WELL API NO. 30-025-00311
5. Indicate Type of Lease STATE ☒ FEE ☐
6. State Oil & Gas Lease No.
7. Lease Name or Unit Agreement Name Rock Queen Unit
8. Well Number 079
9. OGRID Number 330522
10. Pool name or Wildcat Caprock; Queen

PLUG AND ABANDON WELLBORE
ROCK QUEEN UNIT 079
EDDY COUNTY, NEW MEXICO
Class II

Action 516621

Operator: XTO ENERGY, INC 6401 Holiday Hill Road Midland, TX 79707	OGRID: 5380
	Action Number: 516621
	Action Type: [C-103] NOI Plug & Abandon (C-103F)

Rock Queen Unit #079 Proposed WBD

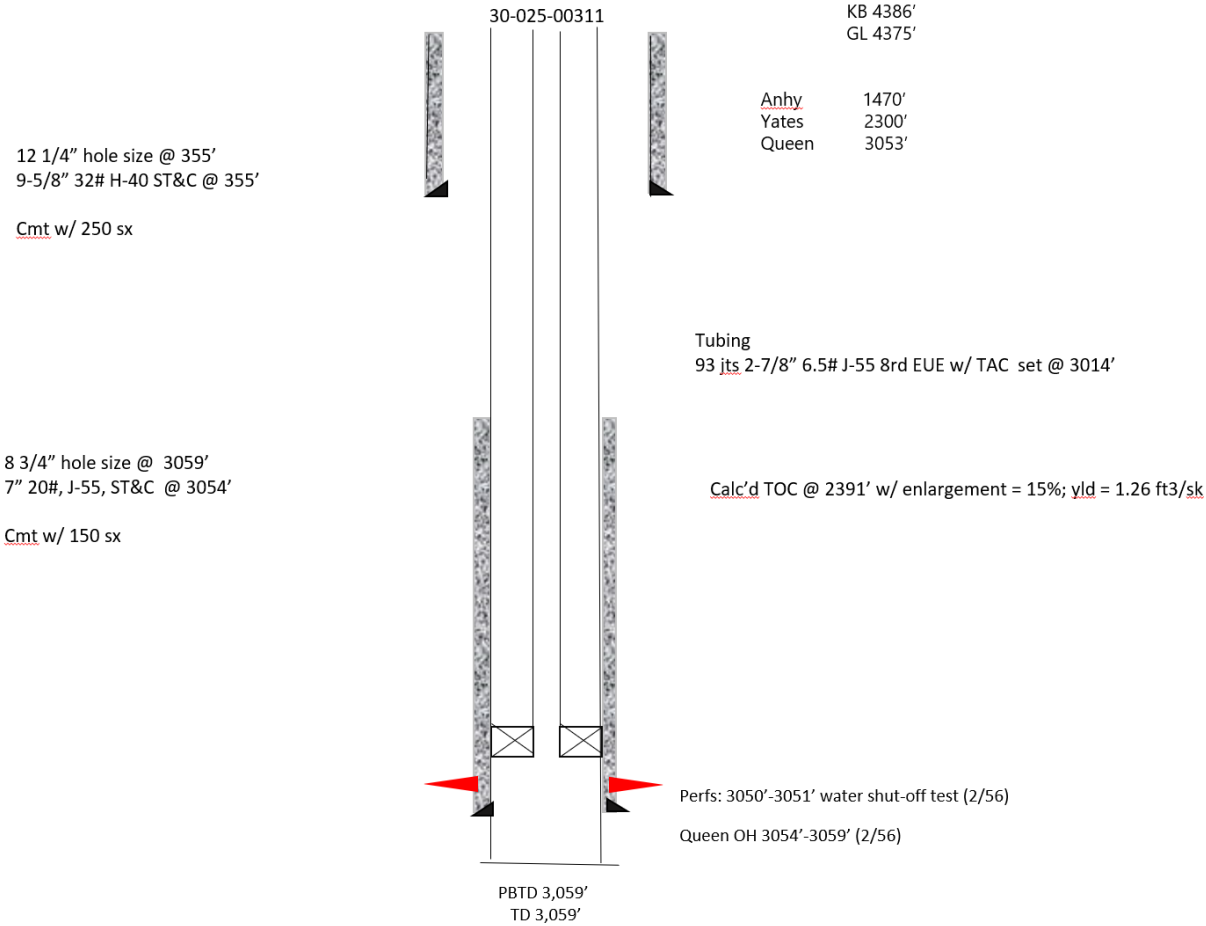
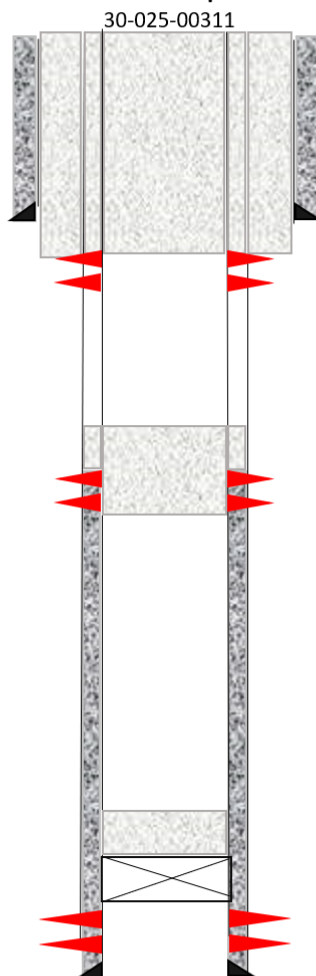
Created By	Condition	Condition Date
loren.diede	Notify the OCD inspection supervisor via email 24 hours prior to beginning Plug & Abandon (P&A) operations.	10/20/2025
loren.diede	Plan to place plug # 2 (spot or perf and squeeze depending on the CBL) from 2450' to 2100' to cover the Yates and base of the Salt.	10/20/2025
loren.diede	NMOCD COAs state that 35' of cement is not adequate to isolate a formation top. Revise by placing at least 50' of cement above the CIBP. NMOCD does not consider this well to be within the LPCH restricted area and an above ground P&A marker is required. Submit photo and GPS coordinates of the P&A marker with the final P&A reports. The API# on the marker is to be clearly legible. Submit the CBL tif file to NMOCD for uploading into the Well Log File.	10/20/2025
